City of Fairfax, Virginia
City Council Work Session

SUBJECT: Discussion of a request by 9571 Fairfax Boulevard LLC for a redevelopment proposal of 9571 Fairfax Boulevard, Tax Map 48-3-06-041.

City Council Work Session

July 2, 2019

CONCEPT EXHIBIT

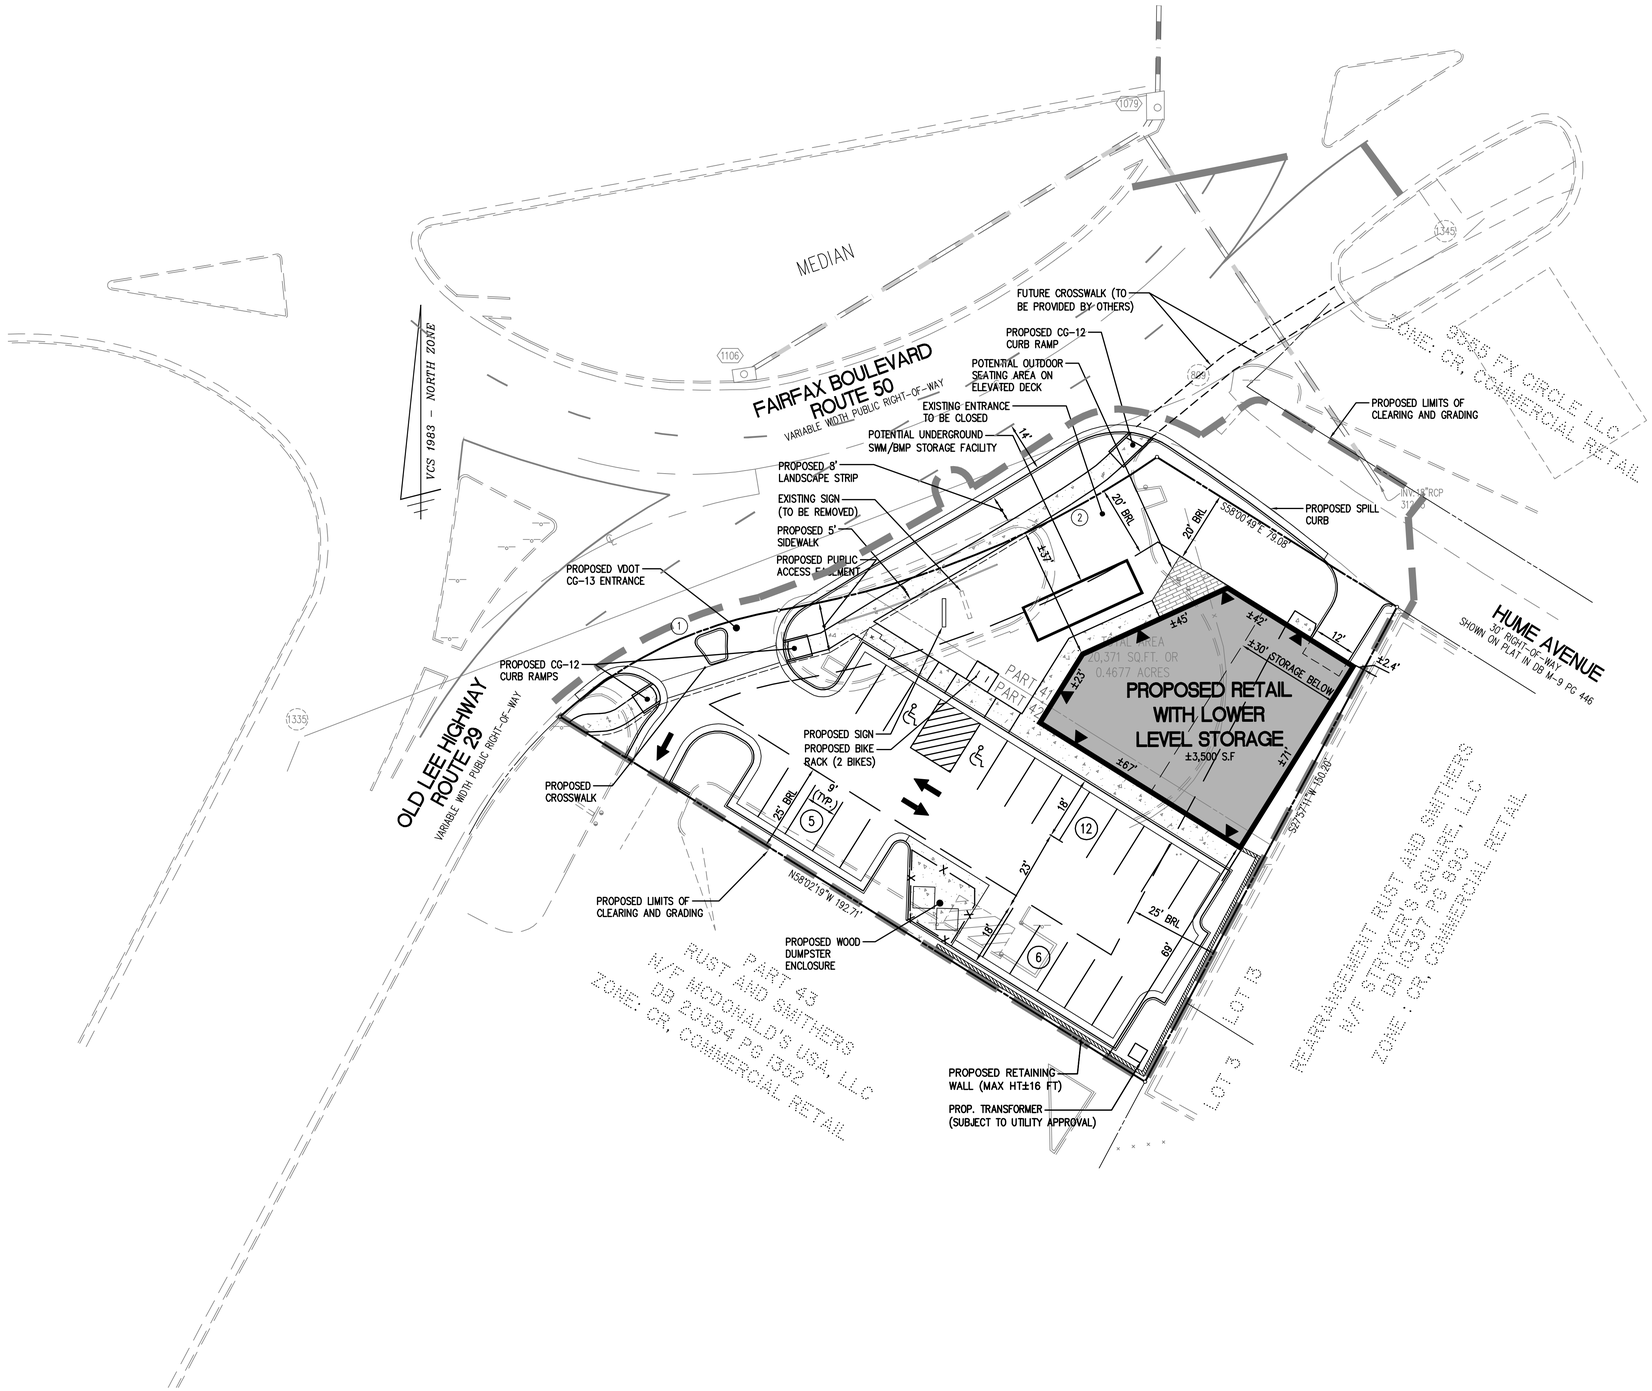
1. Modify the required minimum interior side yard setback.
   -The potential applicant would need to request a 2.4 foot setback from the southeast property line where 25 feet is required. Additionally, the parking areas encroach into the required setbacks from both the southeast and southwest property lines. Parking is not allowed in required yards per §4.2.4.

2. Modify the required minimum street side yard setback.
   -A parking space is shown encroaching into the 25 foot required setback along Fairfax Circle. Parking is not allowed in required yards per §4.2.4.

3. Provide relief from the requirement to provide a sidewalk along a street.
   -No sidewalk is shown along Hume Avenue, a local street, as required by §4.4.4.A.

4. Provide relief from meeting landscape strip and street tree requirements along streets.
   -A 10 foot landscape strip and street trees are required along both Hume Avenue and Fairfax Boulevard per §4.5.6.B.

5. Modify the landscape islands minimum size and spacing requirements.
   -The interior landscape island and one of the terminal landscape islands are smaller than the required 200 square feet and narrower than the required 8 feet inside the curb per §4.5.7.D.
   -An interior landscaped parking lot island is required to be constructed for every 10 parking spaces per §4.5.7.D. One row of parking has 12 spaces with no interior landscaped island.

6. Modify the minimum number of parking spaces required.
   -Restaurant uses are required to provide 1 space for every 200 square feet of floor area per §4.2.3.E. The total floor area, which includes the basement storage space, is shown at 5,630 square feet, which would require 28 parking spaces where 23 are provided.

In addition to the land use requests and certificate of appropriateness, the potential applicant may also need to request a waiver to a Public Facilities Manual (PFM) requirement that loading spaces not be located less than 12 feet from a property line.

1) The triangular curb at the center of the driveway off Fairfax Circle would need to be mountable for emergency vehicle access.

1) Access to the site would be limited to the right-in, right-out from Old Lee Highway traveling northbound.
2) Staff supports the removal of a curb cut from close proximity to the intersection of Fairfax Boulevard and Hume Avenue, which would prevent cut-across traffic on the circle.
3) Staff supports reducing the width of the outside lane of the circle to build a sidewalk in alignment with other sections of sidewalk, and to make the outside traffic lane less arbitrary in width.
4) Staff supports the exception to the sidewalk requirement on Hume, but believes that the 10-foot right-of-way should be reserved here so that a sidewalk could be constructed at a future date if future conditions of surrounding sites would justify this.
